**Banyule City Council, Boroondara City  
Council, Manningham City Council,  
Whitehorse City Council**

**North East Link EES**

**Review of Matters Relating to Surface Water**

**July 2019**

Figure 4-1 NELP Banyule Creek catchment model layout

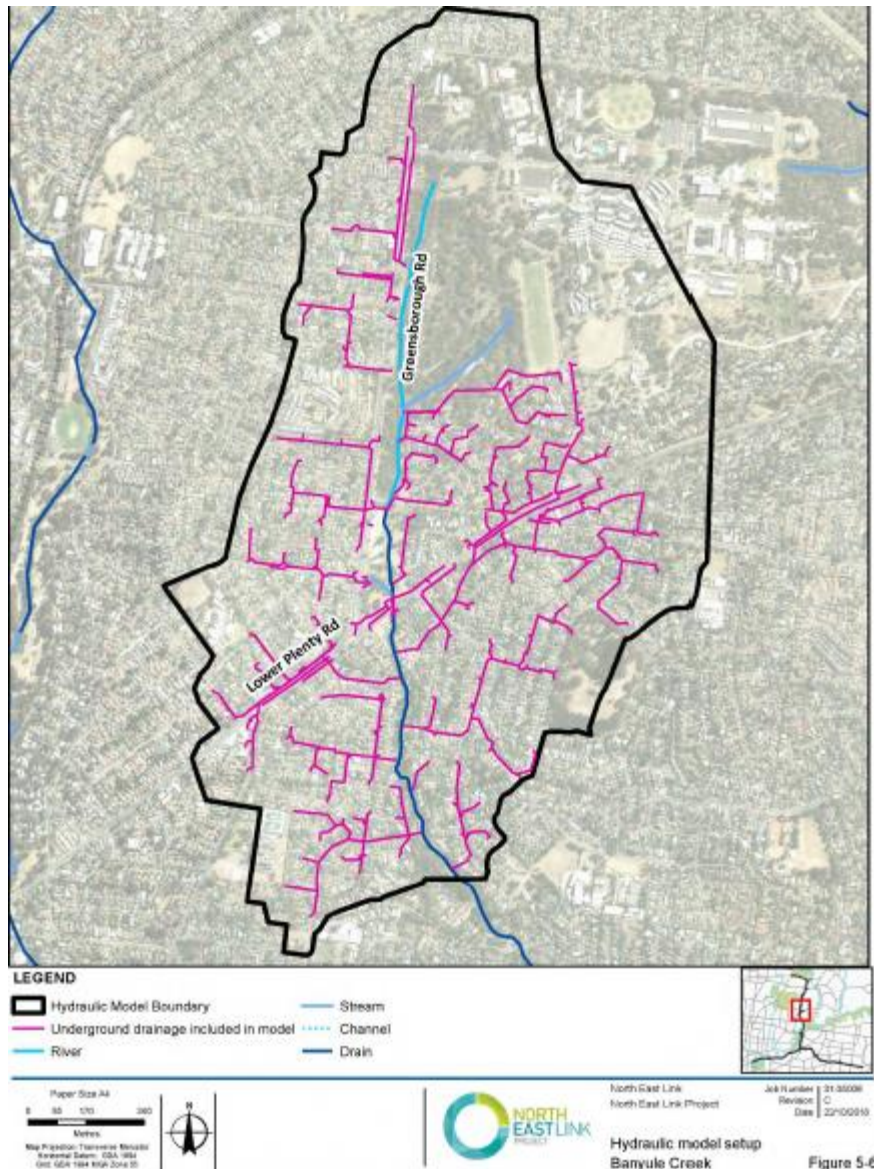
I disagree with NELP's response and this is best highlighted by presentation of some examples. As shown in Figure 4-1 (an excerpt from the Surface Water Technical Report), a whole of catchment approach was adopted for the Banyule Creek catchment. This approach includes all Council and Melbourne Water underground drainage and waterway assets in the modelling.

**Figure 4-2 NELP Banyule Creek modelling results**

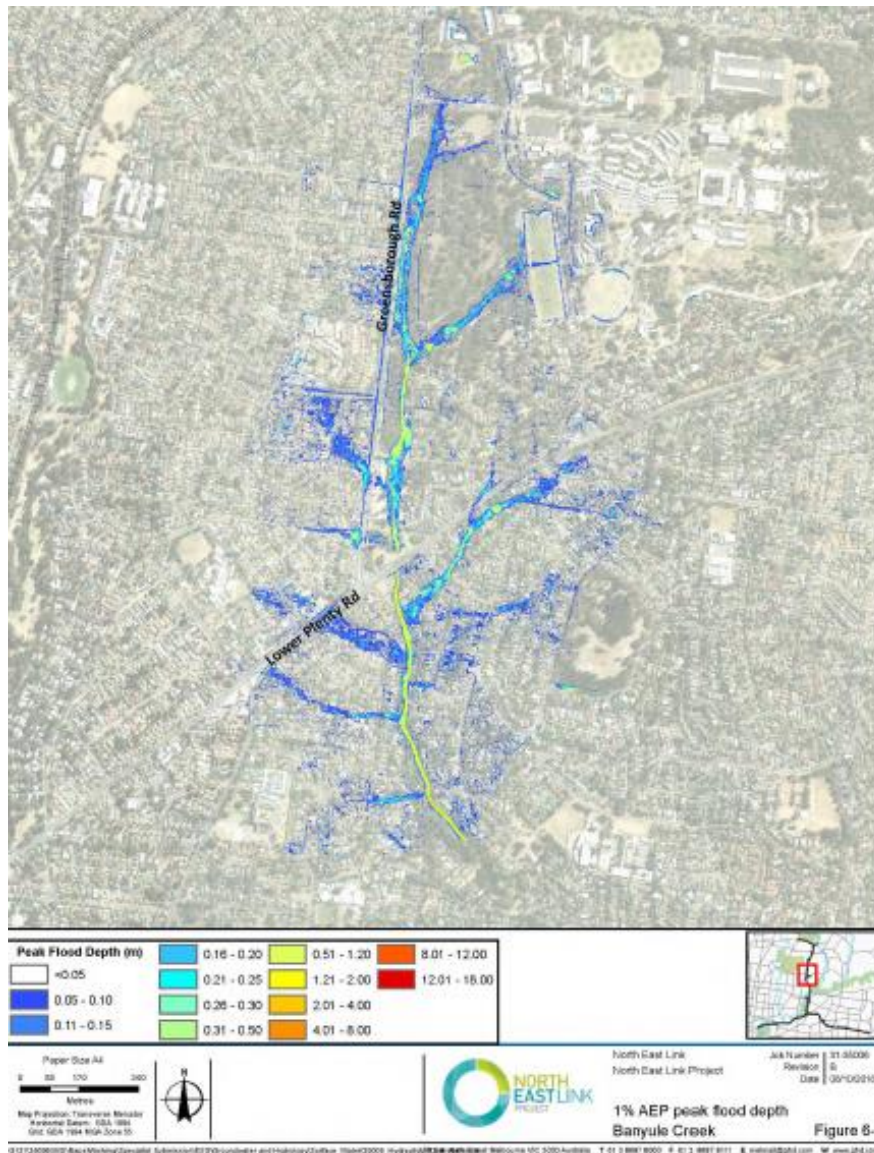
The results produced from this modelling approach to estimate flooding in the Banyule Creek catchment are presented in Figure 4-2 (an excerpt from the Surface Water Technical Report) and highlights the extent of flooding across the catchment after filtering of flood depths less than 50mm.

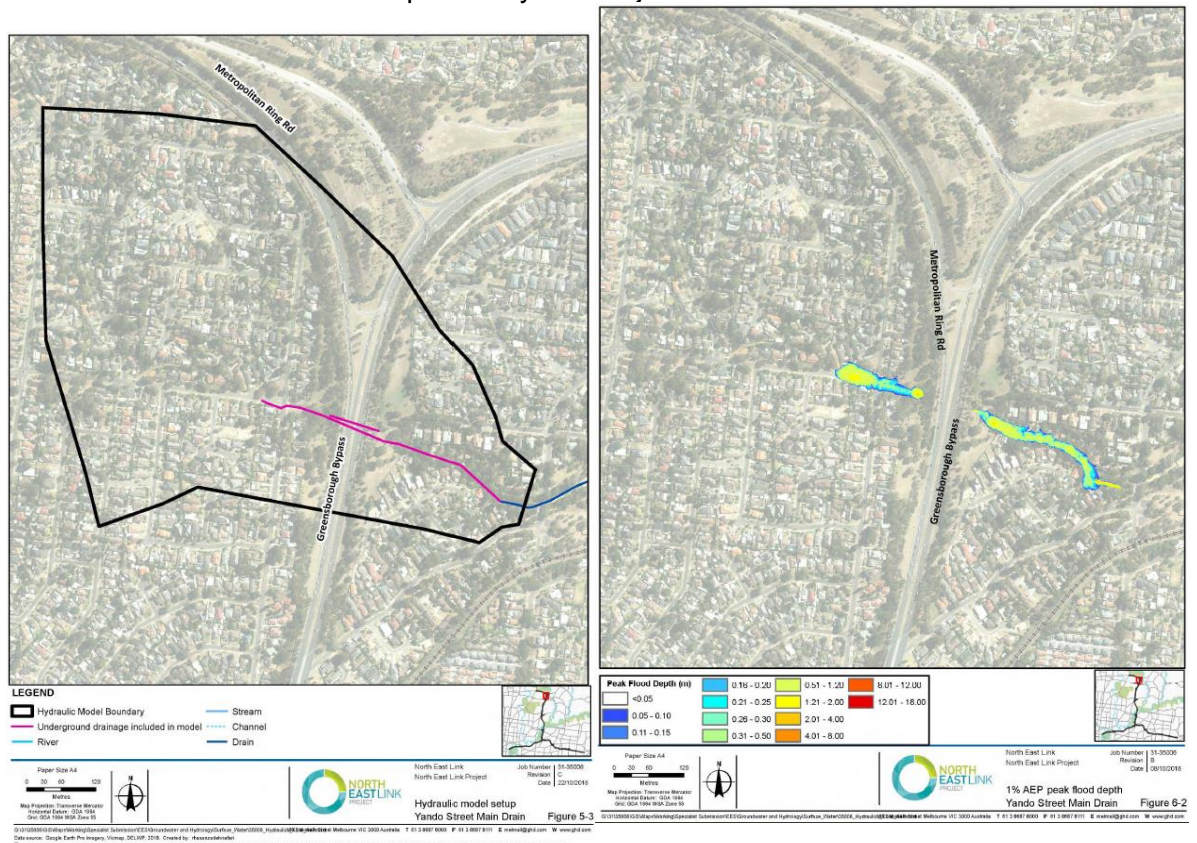
impacted by the Project but have not been included as part of the EES modelling. Figure 4-3 (an excerpt from the Surface Water Technical Report) depicts the modelling extent of the Yando Street Main Drain catchment which only includes the Yando Street Main Drain (a Melbourne Water drainage asset) and the pedestrian underpass beneath Greensborough Highway as assets capable of conveying catchment flows. In the model provided to NELP by Engeny at the written request of Melbourne Water the full extent of the Yando Street Main Drain and Kempston Street Main Drain catchments were included within the same model as they connect into each other on the eastern side of Greensborough Highway before discharging to Kalparrin Gardens where Banyule City Council own and manage a large stormwater harvesting system.

The approach adopted by NELP has failed to acknowledge that there are locations in the Yando Street Main Drain catchment where overland flows in large storm events will flow into the Project area and be impacted by the Project. The consequence of this is that there are areas that will be impacted by the Project that are not identified by NELP’s modelling.

The results produced from the NELP Yando Street Main Drain catchment model are presented in Figure 4-3 (an excerpt from the Surface Water Technical Report). The results show that the extent of flooding associated with overland flows is limited to the drainage assets that have been modelled. This is not a true reflection of flooding within the catchment that could be impacted by the Project.

Figure 4-4 Extent of flooding from Melbourne Water flood model showing areas of flooding within the Project area not included in NELP modelling

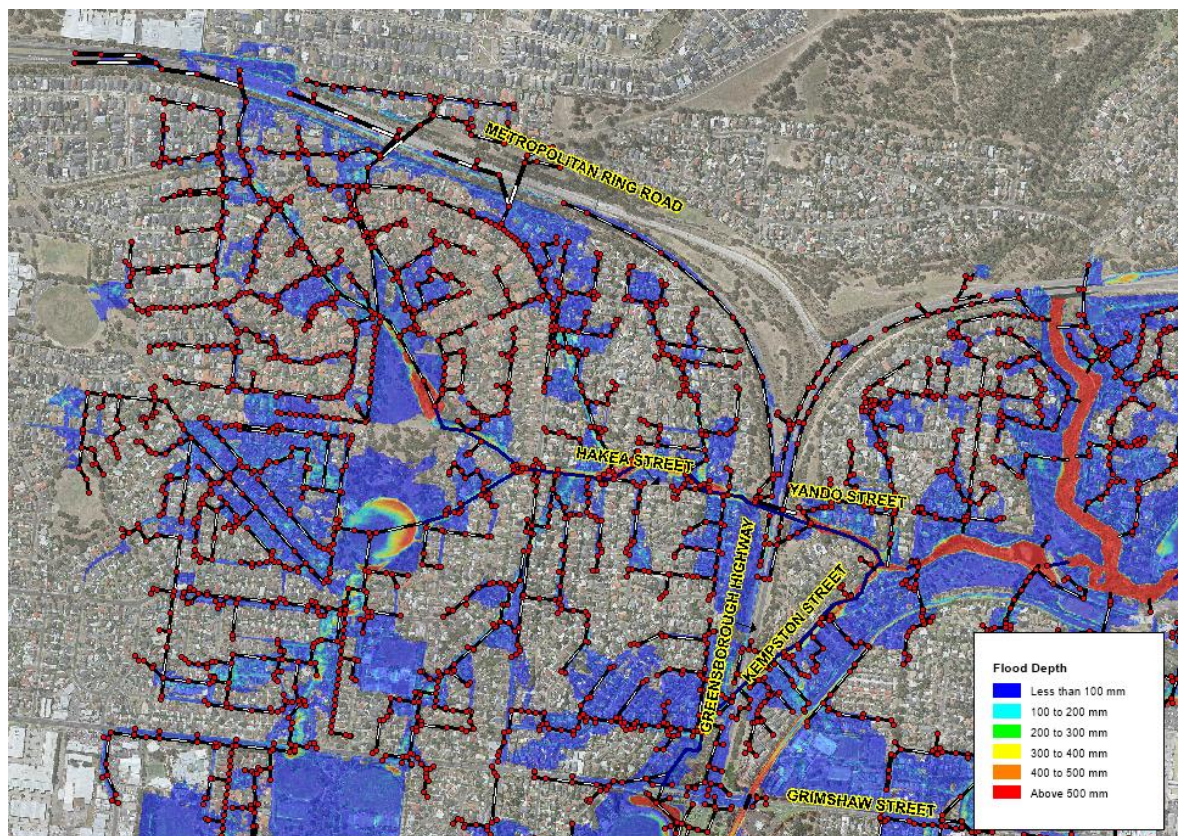
Figure 4-4 presents the full extent of drainage assets and 1% AEP overland flows within the Melbourne Water flood model that was provided to NELP containing both the Yando Street Main Drain and Kempston Street Main Drain. This modelling is based on a whole of catchment approach and highlights several locations within the Project area where the Project will have an impact on existing flooding based upon a review of the nature and extent of works presented in the North East Link EES Map Books.

I recommend that the Melbourne Water flood model that was provided to NELP be used to assess existing conditions flooding within the Yando Street Main Drain and Kempston Street Main Drain catchments. This will enable the combined effects of the project to be determined appropriately when assessing the impact of the Project.

Figure 4-5 NELP Koonung Creek flood model extent

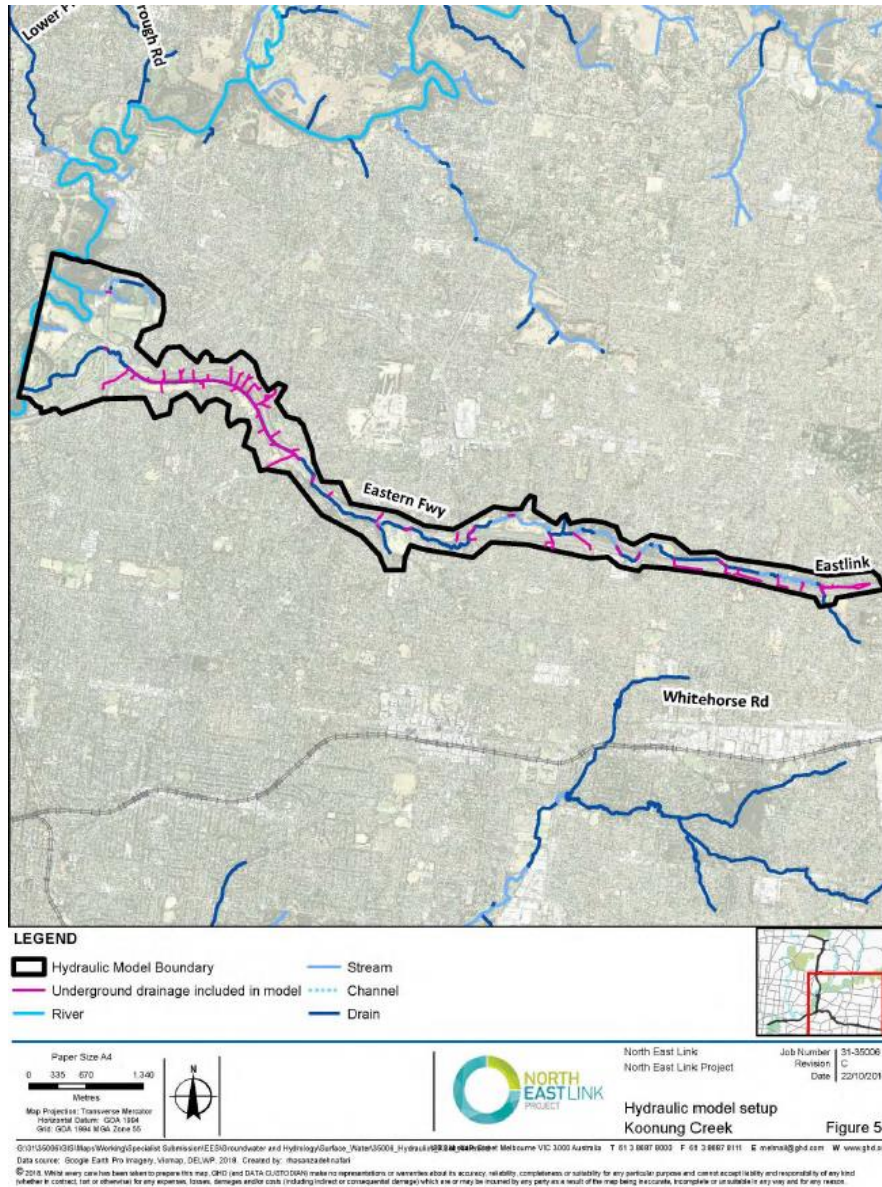
Another example of the simplified modelling approach is the Koonung Creek catchment model. The Surface Water Technical Report acknowledges that local catchment flooding has not been allowed for *“The hydraulic model extent includes, the entire 12-kilometre length of Koonung Creek. While inflows have been carefully considered, flooding on the tributary streams (local catchment flooding) has not been explicitly modelled.”*<sup>2</sup> Figure 4-5

(an excerpt from the Surface Water Technical Report) depicts the extent of NELP’s modelling for the Koonung Creek catchment.

Figure 4-6 Example of Koonung Creek flood modelling results

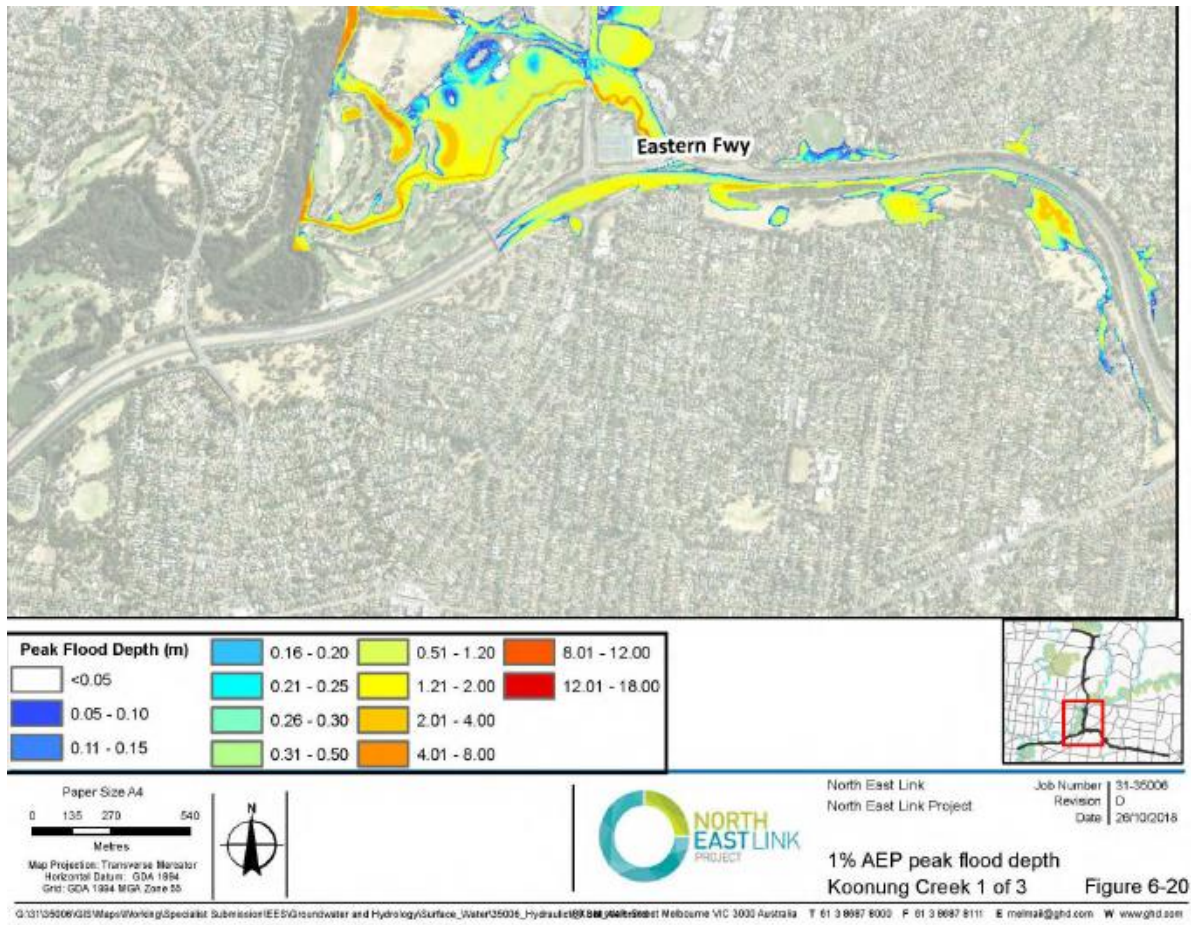
An example of the results produced by the NELP Koonung Creek catchment model is presented in Figure 4-6 (an excerpt from the Surface Water Technical Report).

**Figure 4-7** Example of extent of Boroondara City Council flood modelling within Koonung Creek catchment

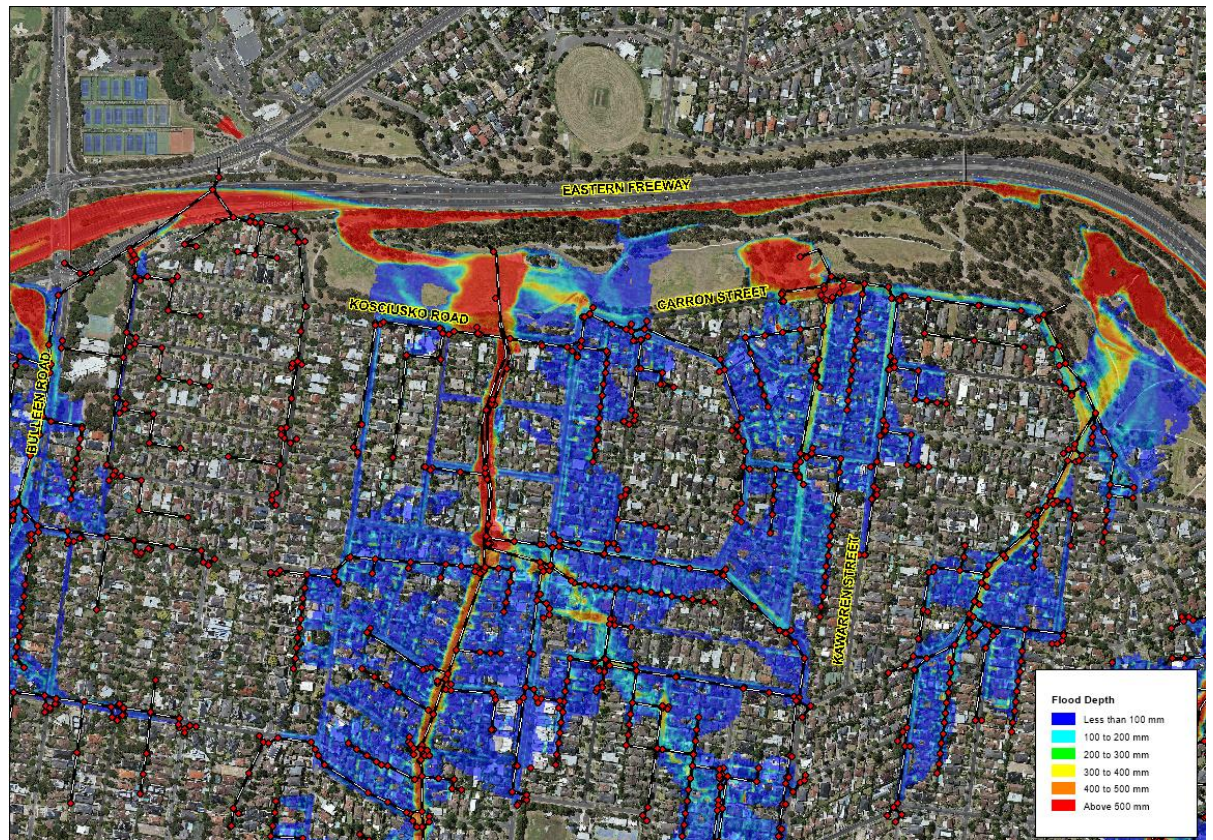
Flood modelling undertaken for Boroondara City Council has included all Council drainage assets and overland flows that drain into Koonung Creek. Figure 4-7 presents an example of Council's flood modelling results (1% AEP) and identifies that the extent of flooding within Koonung Creek Reserve is more extensive than that predicted by the NELP modelling. As a result the flood impact assessment undertaken for the EES does not identify the full extent of impacts arising from the Project at this location.

Figure 4-8 Coarse flood modelling results of local catchment flows within the City of Whitehorse

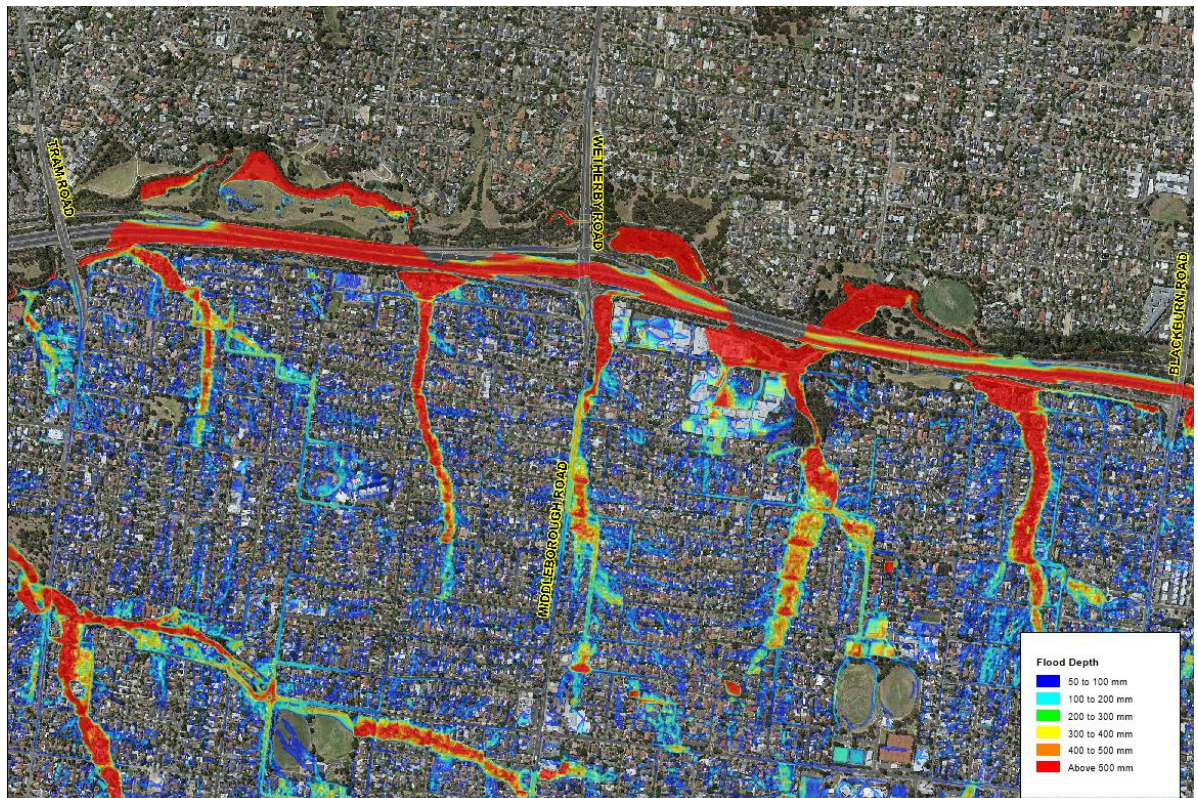
The City of Whitehorse has not undertaken detailed flood modelling of the areas within the municipality that could be impacted by the Project. As part of my assessment I have developed a coarse flood model to identify and assess the local catchment flow paths within the City of Whitehorse that are likely to be impacted by the Project and have not been captured as part of the modelling assessment. An example is provided in Section 4.3.2 whereby local flooding within the City of Whitehorse has not been included as part of the NELP modelling and will be impacted by the Project.

The model is coarse in the sense that no drainage assets have been included, however the intent is to define the approximate extent and local catchment flow paths that could potentially be impacted by the Project. Figure 4-8 presents an example of the results of this modelling and identifies several key flow paths that flow toward the Eastern Freeway. Many of these flow paths are likely to be impacted by the Project given that the Eastern Freeway is proposed to be widened resulting in the road reserve being expanded to the south resulting in the loss of flood storage and potentially increasing flood levels within surrounding properties.

Figure 4-10 Carron Street Afflux (results from Surface Water Technical Report Appendices)

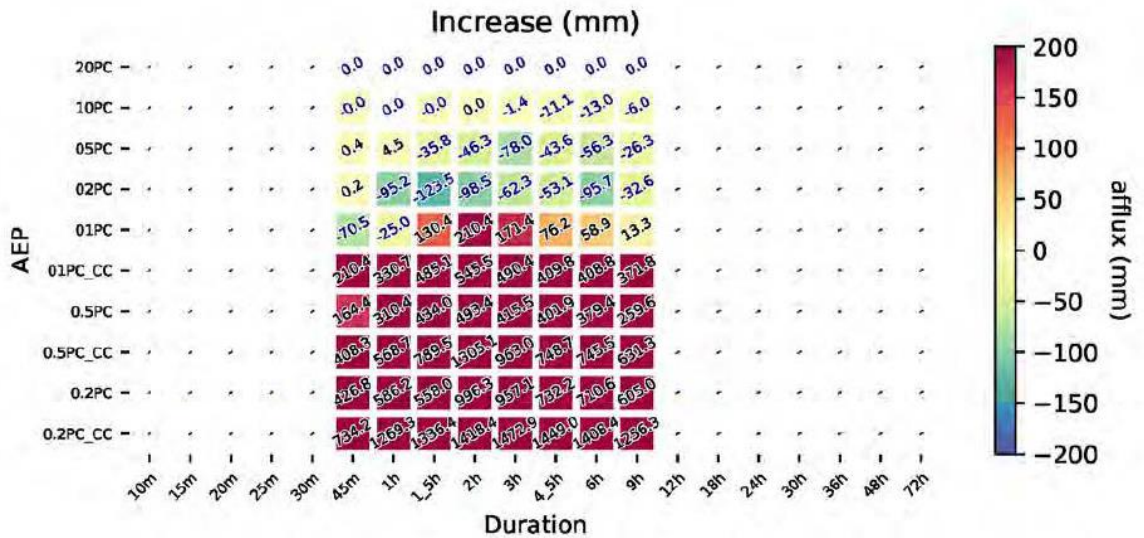
- Carron Street, Balwyn North (maximum predicted increase approx. 545mm for 1% AEP with allowance for climate change as depicted in Figure 4-10)
- Eram Road Property, Box Hill North (maximum predicted increase approx. 547mm for 1% AEP with allowance for climate change as depicted in Figure 4-11)

As such the extent of works required to address the increases predicted at these locations, amongst other locations, is unknown.
